Planning & Zoning Commission

September 26, 2016

Subject: Consider recommending approval of the site plans for Dance Vision, located at 8711 Thomas Avenue (PZ Case 16-29).

LAYOUT PLAN

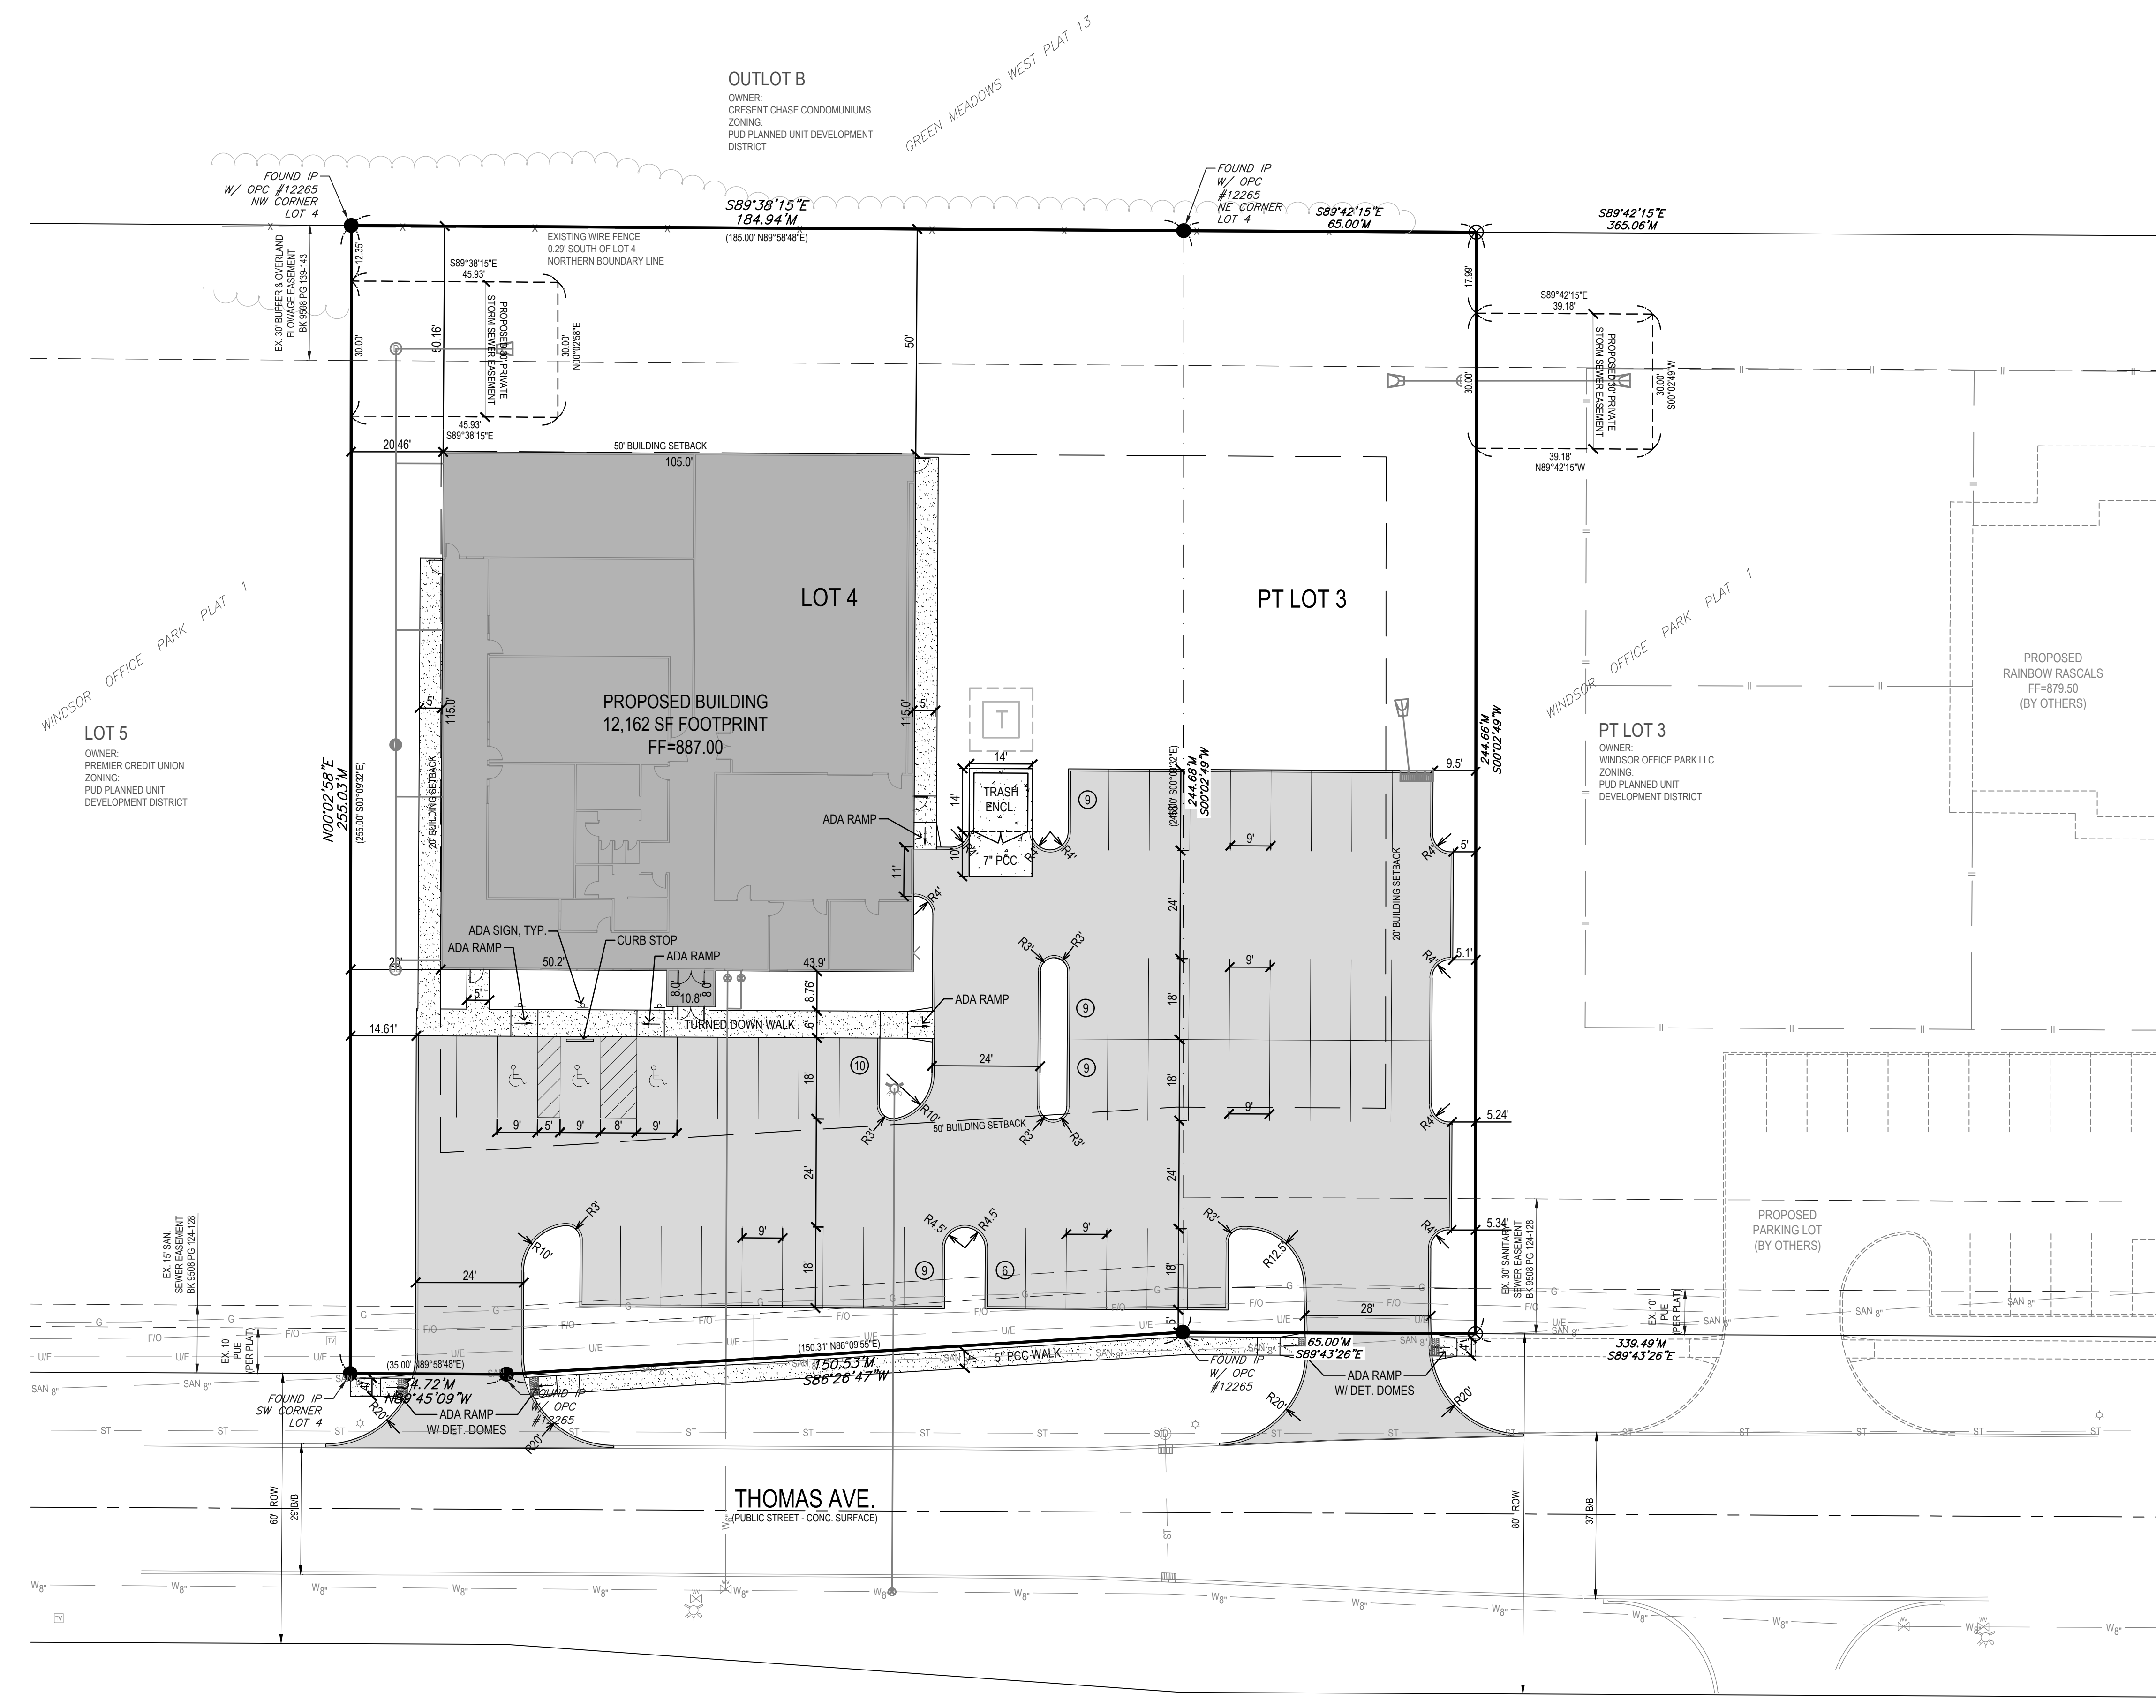
- a. Address items 1-15 of the review letter provided by consulting engineer Foth Infrastructure and Environment dated September 22, 2016.
 - b. A recorded easement is necessary to install approximately 36’ of storm sewer pipe and an outlet structure on the east-adjacent property.

<p>TRAFFIC ACCESS & CIRCULATION:</p>	<p>The site has two points of access on Thomas Avenue. This will be a full access driveway.</p>
<p>PEDISTRIAN CIRCULATION & SIDEWALKS:</p>	<p>A four-foot wide sidewalk will be installed along Thomas Avenue Thomas Avenue.</p>
<p>PARKING AND LOADING:</p>	<p>In determining the required parking for the subject property, staff utilized the provision for colleges, trade schools and other places of learning – which requires 1 space for every person regularly employed (maximum working shift) plus one space for each three student desks or classroom seating facilities. While the studio won't have seating, each room would have a maximum capacity for students. The client capacity is estimated at</p>

139 persons and the applicant reports five employees. These numbers lend a parking requirement of 52 parking stalls. The site plan is in compliance with 52 stalls.

The total site area is 62,286 s.f.. The open space ratio for this PUD requires a minimum of 30% of the total property area, or 18,686 s.f.. The site is in compliance with 46% open space, or 28,895 s.f..

For this site, 13 trees and 19 shrubs are required and the site plan is in compliance.

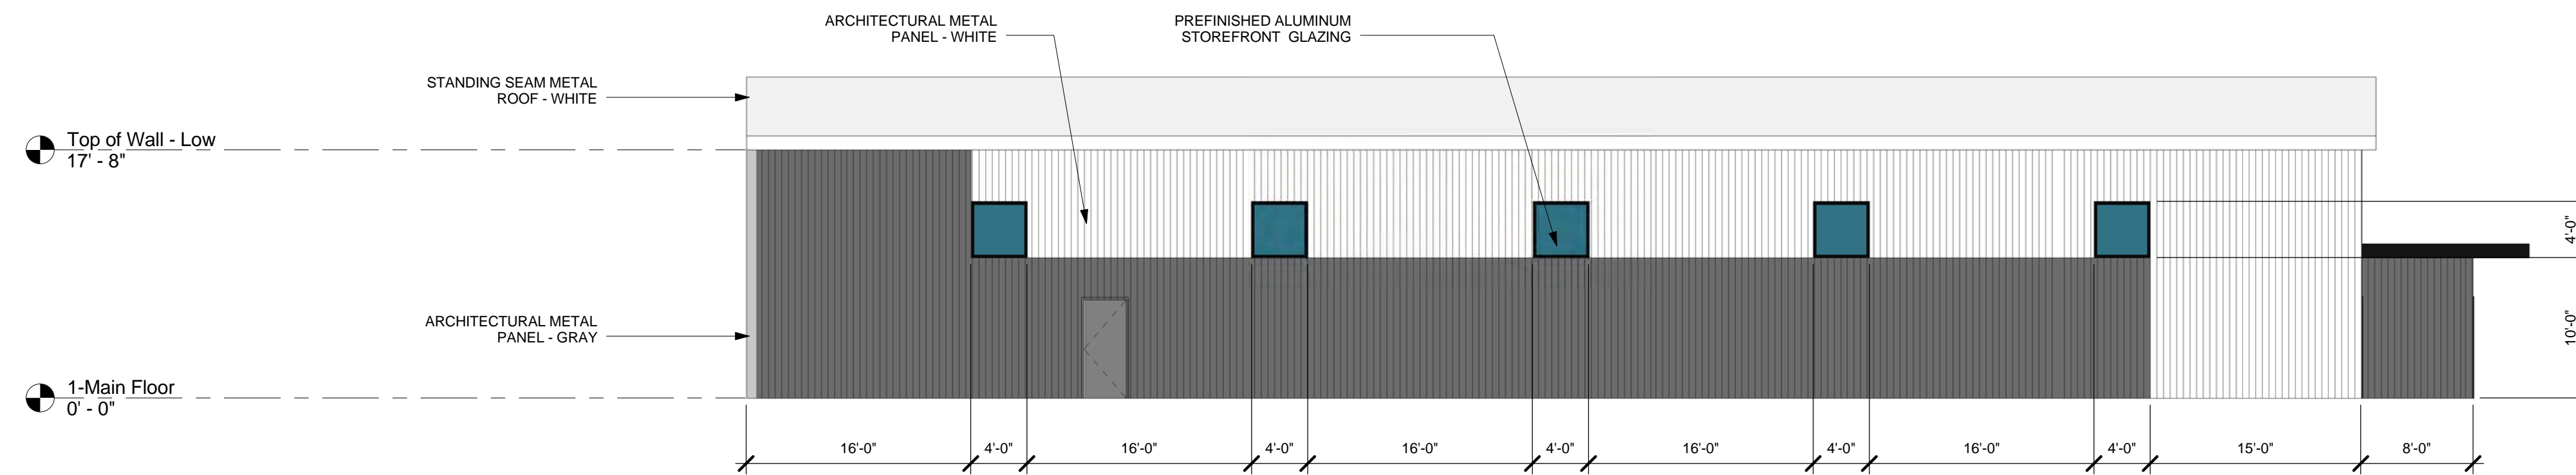
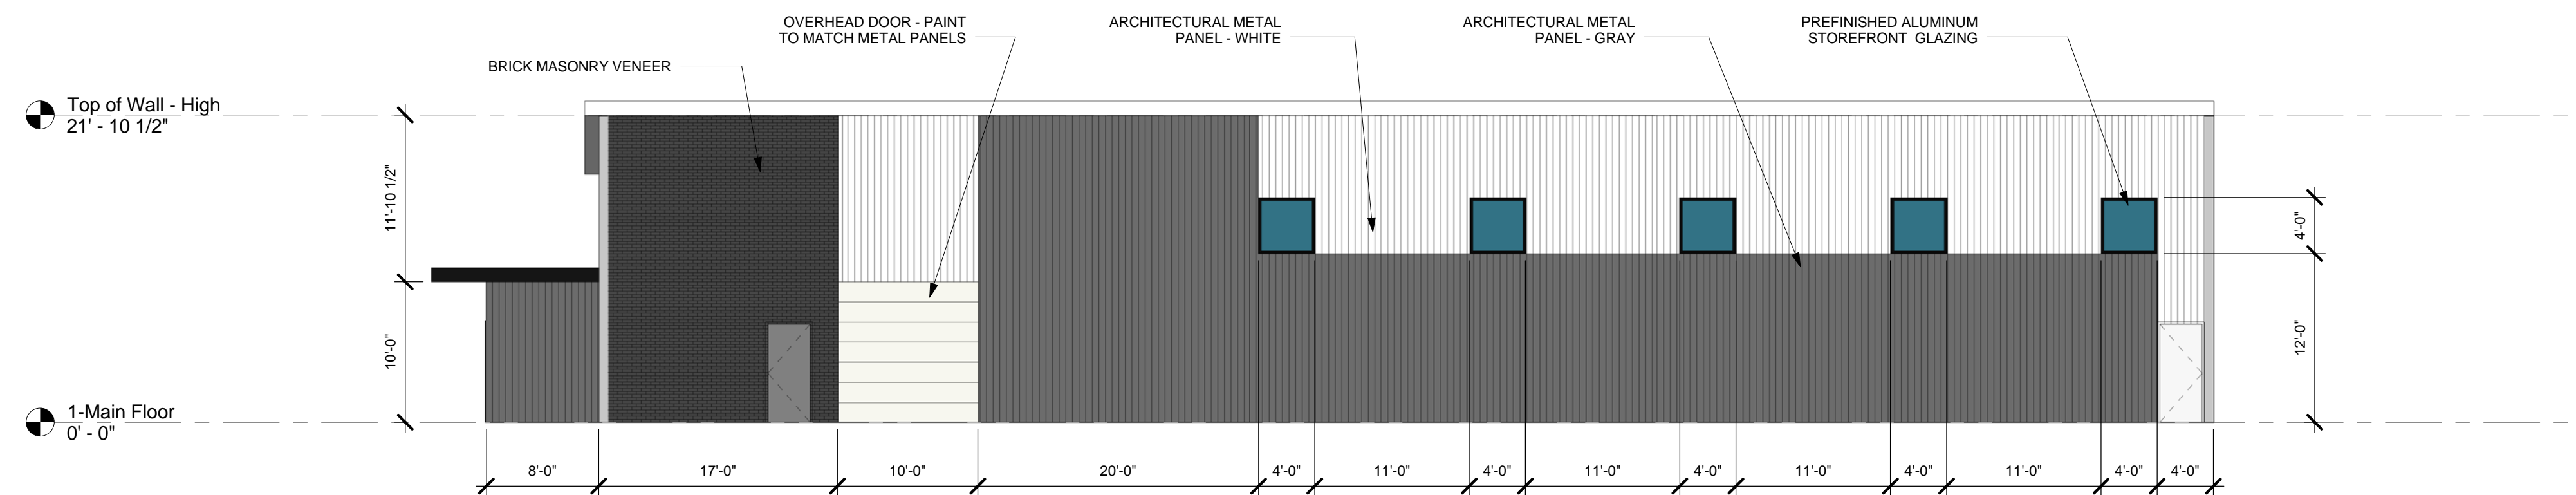
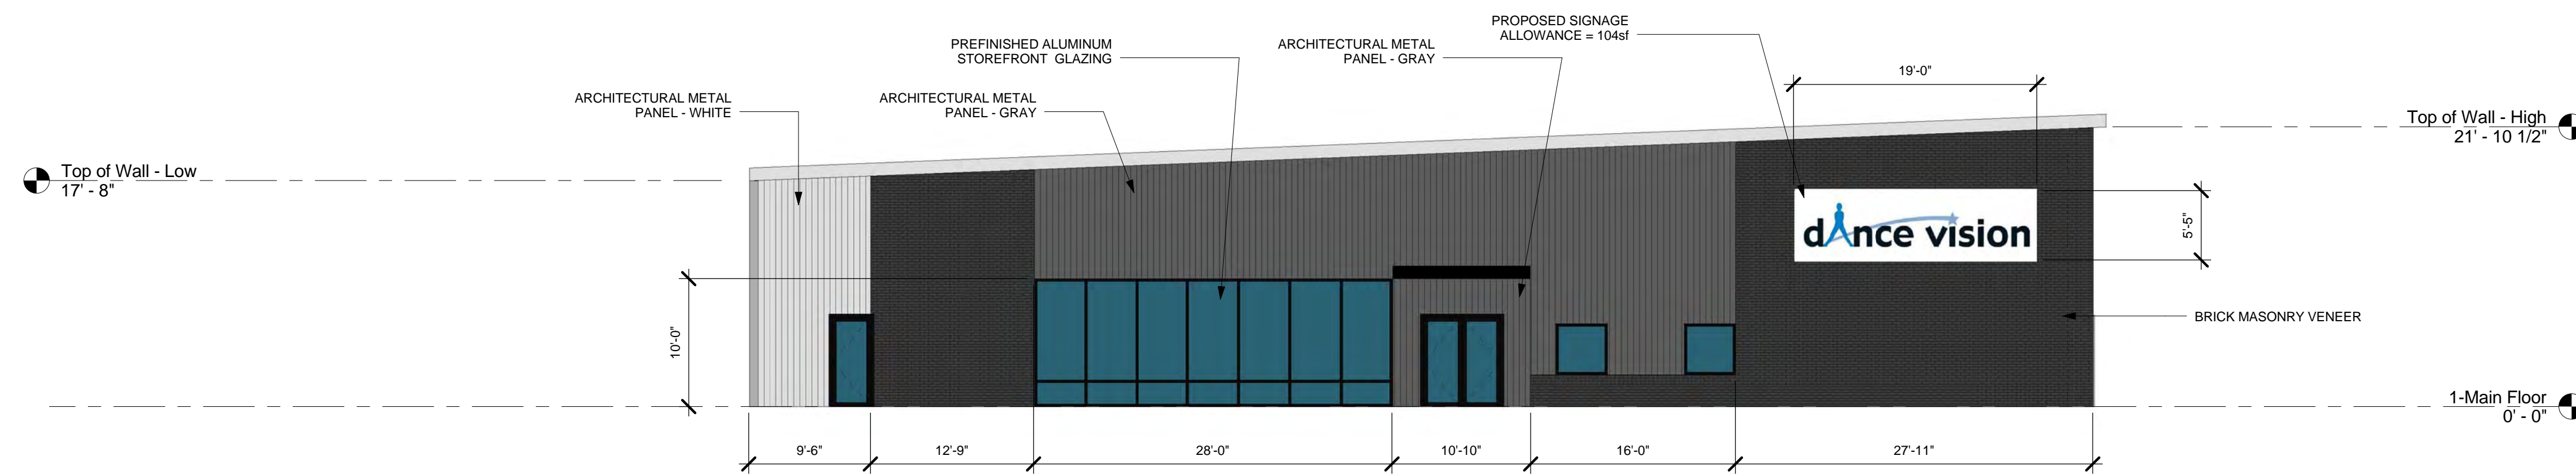
Chapter 166.35 of the City Code requires 75% of the building's wall area (excluding glass) to consist of permanent materials, to include a combination of brick, architectural concrete panels, textured concrete block, architectural steel, and stone panels. In addition, the PUD requires the project adhere to the architectural requirements for buildings within 300' of NW 86th Street (Chapter 166.35.D), which states that nonresidential buildings abutting Merle Hay Road, NW 86th Street and NW 62nd Avenue shall have brick constitute at least 50% of the wall area that faces the arterial street, excluding glass.

The materials proposed for this site meet the above-stated requirements, with brick constituting 51% of the building exterior facing Thomas Avenue, and the alternate building sides comprised primarily of architectural metal panels.
